RFP Addenda – Playground Equipment for Butler Children’s Park

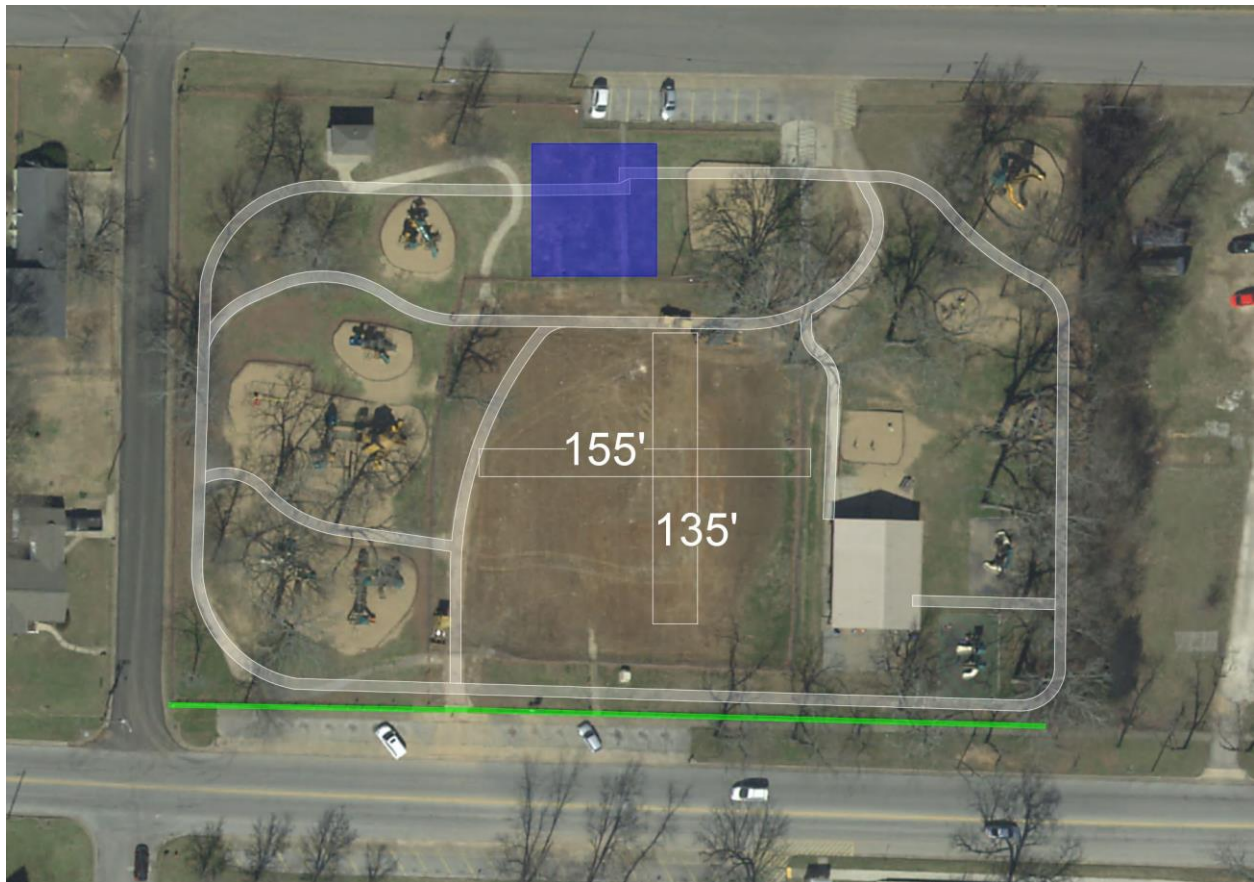
Q: Do you have an area size minimum or maximum you prefer we work within?

A: Please see below map of the maximum proposed location.

The Map shows the area the playground will go, that is not to say the actual piece of equipment will span that full size as there are cost restraints just that it is the available area.

The Map also shows the approximate location and size of the Splash Pad that has recently been installed. The City will want to tie into this somehow whether by ramp or feature.
